AGENDA

PARK CITY MUNICIPAL CORPORATION
HISTORIC PRESERVATION BOARD
MINUTES OF DECEMBER 5, 2012

Marsac Affordable Housing Subdivision
Units 1-10 Silver Hills Court

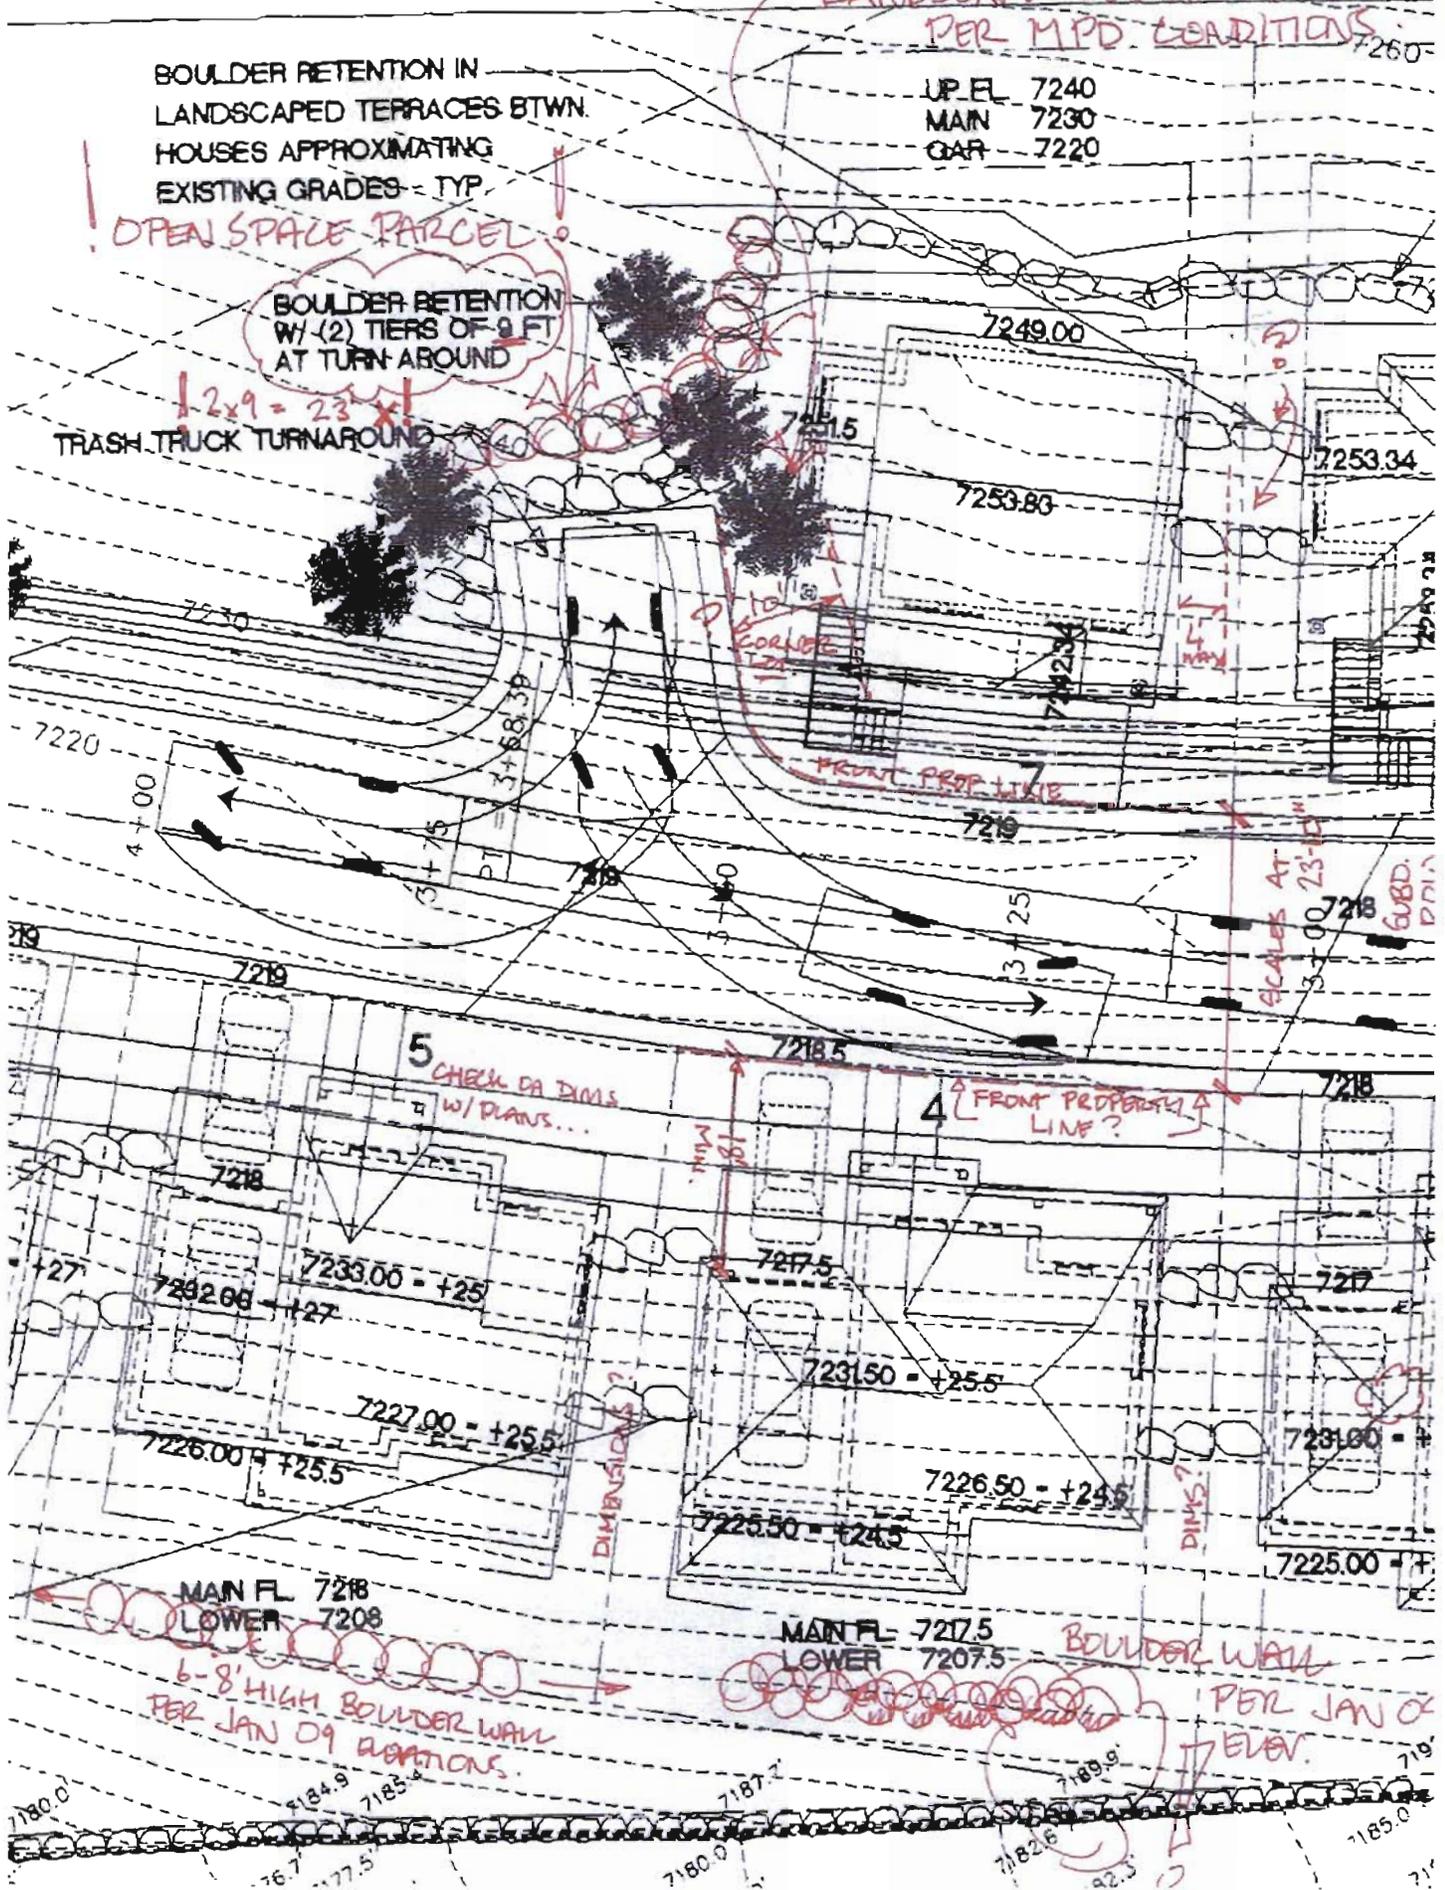
LANDSCAPE DETAILS PLEASE PER MPD CONDITIONS

BOULDER RETENTION IN LANDSCAPED TERRACES BTWN. HOUSES APPROXIMATING EXISTING GRADES - TYP.
